STATE OF NORTH CAROLINA
DEPARTMENT OF TRANSPORTATION

Subject: **Modification to Section 404 Individual Permit and Section 401 Water Quality Certification and Neuse Buffer Certificate** for Northern Wake Expressway from NC 55 west of Morrisville to 0.7 km northeast of I-40 in Wake and Durham Counties (TIP Nos. R-2000AA, R-2000AB; and R-2000AC); State Project No. 8.U401711; Federal Aid Project No. NHF-123-1(11). USACE Action ID No. 200021863 (Previous Action ID. No. 199920387 and Action ID No. 199601917), NCDENR-DWQ Project No. 030918; \$475.00 Debit WBS Element 34365.1.2

The North Carolina Department of Transportation (NCDOT) is currently constructing a portion of the Northern Wake Expressway in Wake and Durham Counties (R-2000 Sections AA, AB and AC). The United States Army Corps of Engineers (USACE) originally issued an Individual Permit for this project on October 10, 1996. The USACE issued a permit modification for the construction of this project on November 25, 2003. The North Carolina Division of Environment and Natural Resources, Division of Water Quality issued the 401 Water Quality Certification No. 3439 (NCDENR-DWQ Project No. 030918) for this project on October 7, 2003

SITE II
PLAN VIEW
 SCALE= 1:1000

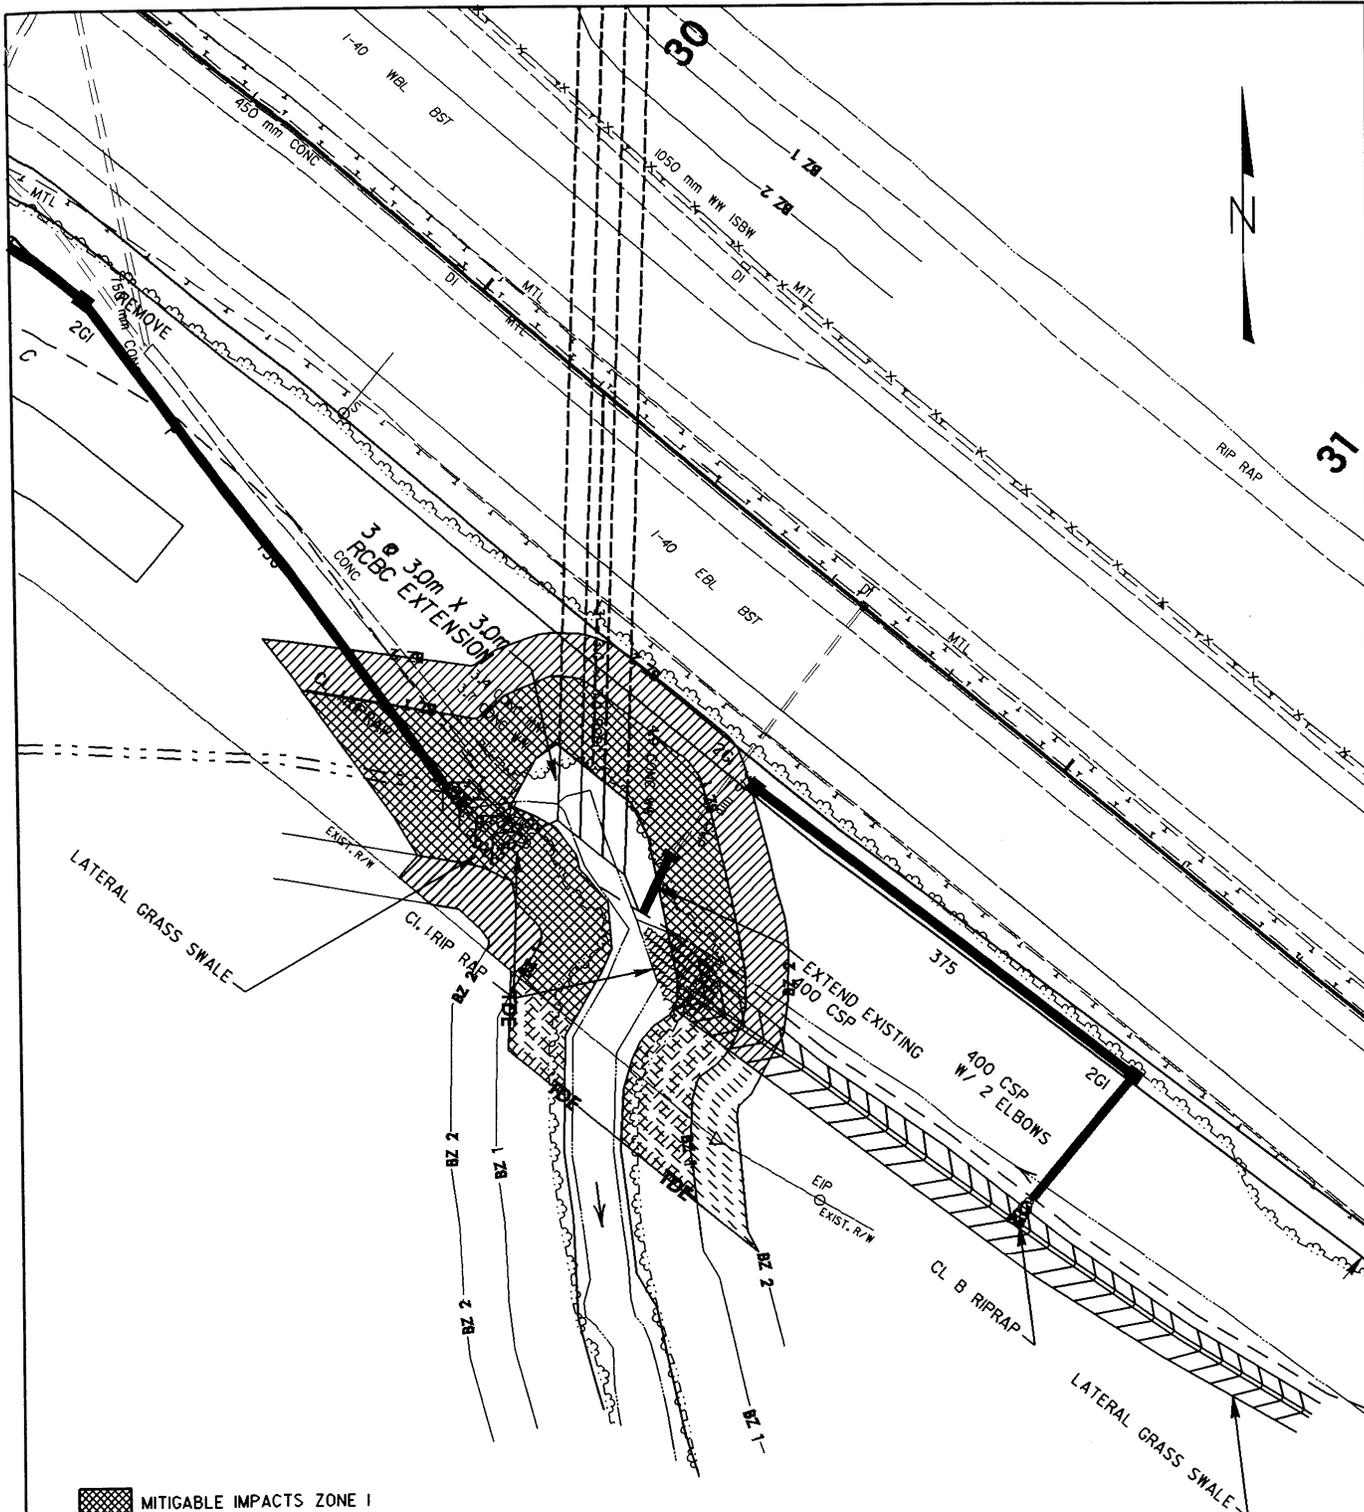
Issue: The stream impacts permit drawing (11/26/02), buffer impacts permit drawing (11/26/02) and plan sheets indicate that two lateral grass swales will be constructed along the southern toe of fill. A recent review of the site has indicated that Class I rip rap must be placed at the terminal portions of the swales inside the riparian buffer.

Status: The stream impacts permit drawing and buffer impact permit drawings have been modified (3/18/04) to depict the placement of the Class I rip rap in the lateral grass swales.
